MEMORANDUM

SUBJECT: AMENDMENT TO DEVELOPMENT PLAN AND PLANNED DEVELOPMENT
AREA FOR HARBOR POINT PROJECT ON THE
COLUMBIA POINT PENINSULA

First Amendment To
Development Plan
For
Planned Development Area #22
Harbor Point At Columbia Point

Peninsula Partners/Columbia Point Community Task Force, Inc.

EXHIBIT 1 TO PDA PLAN AMENDMENT

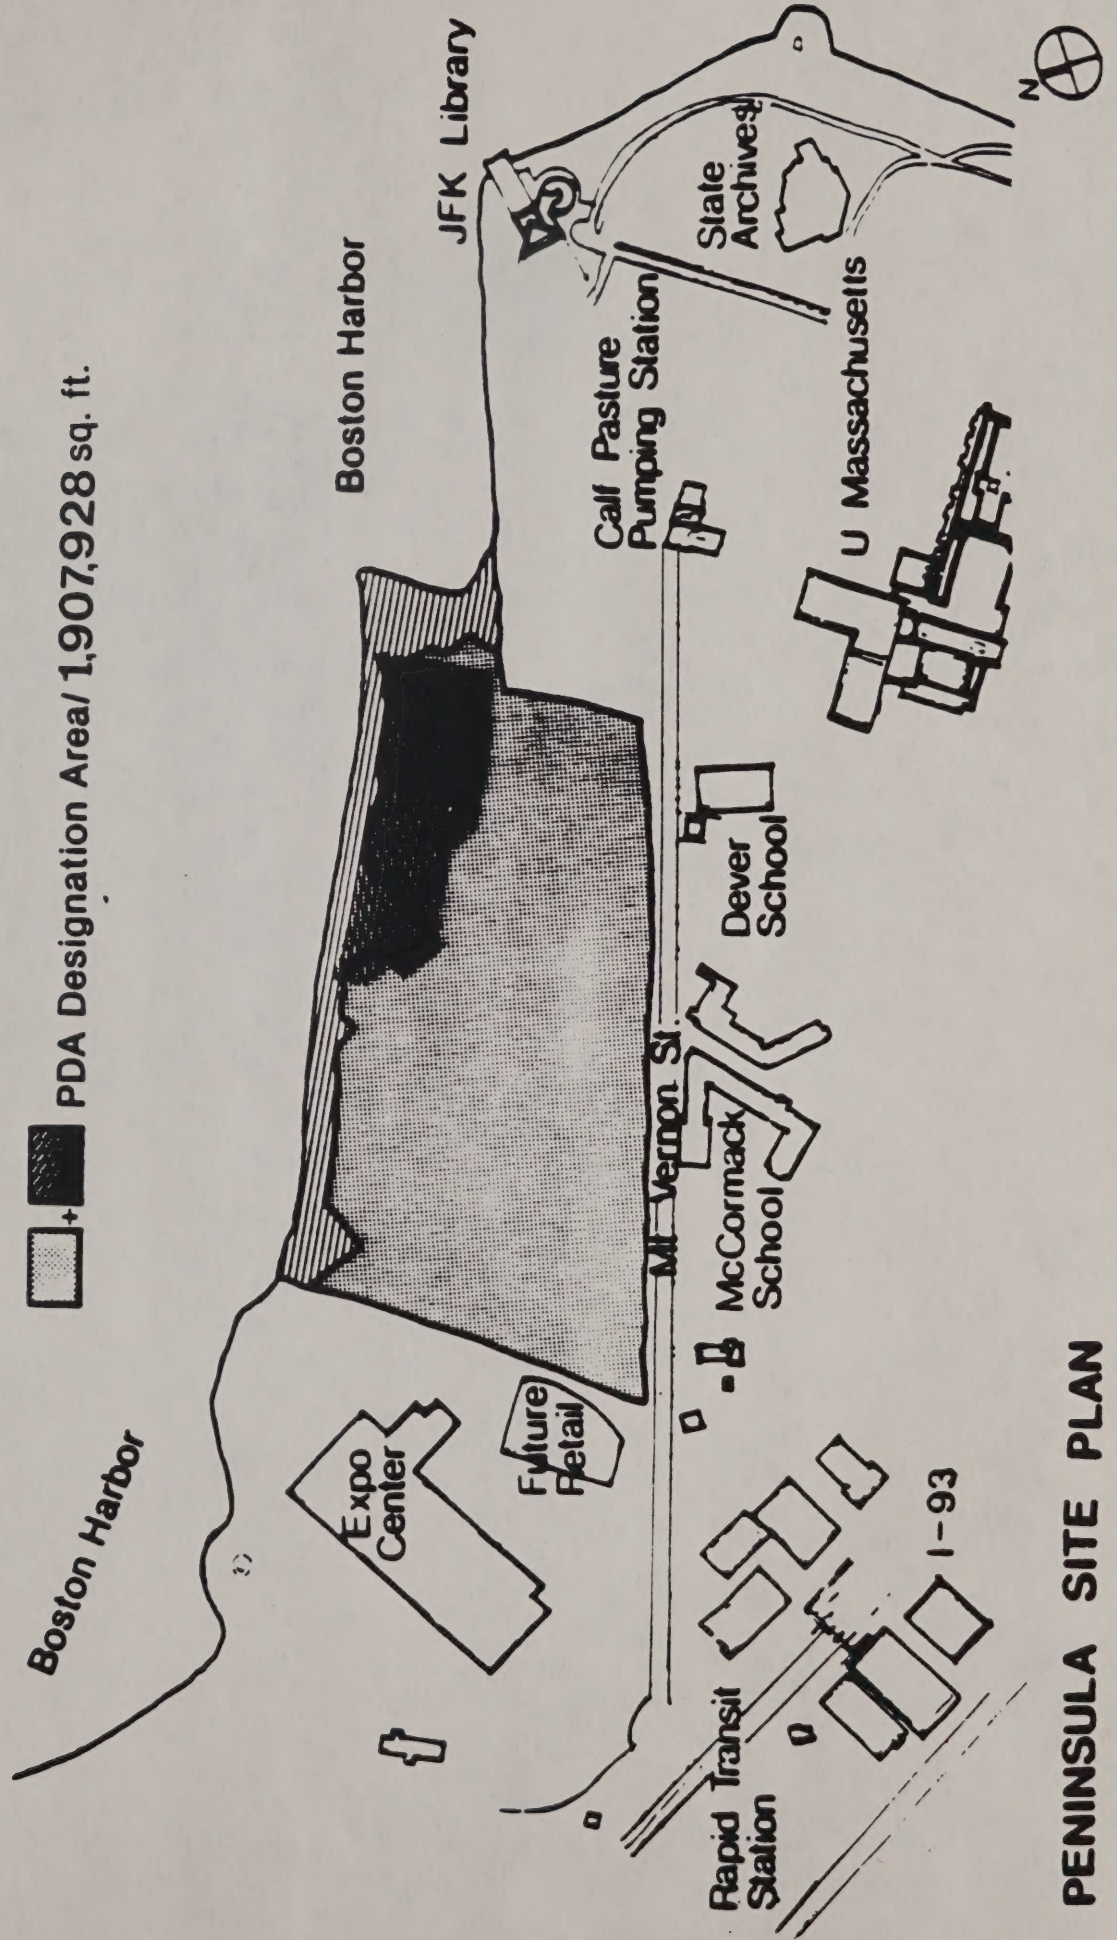
1. The first sentence of the section of the Plan entitled "Location and Description of Site" is hereby amended by deleting therefrom the number "1,952,047" and inserting in lieu thereof the number "1,907,928".

10. Exhibits IA, II, IX and X of the Plan are hereby deleted and the new Exhibits 2, 3, 4 and 5 respectively, attached hereto are hereby substituted in lieu thereof.
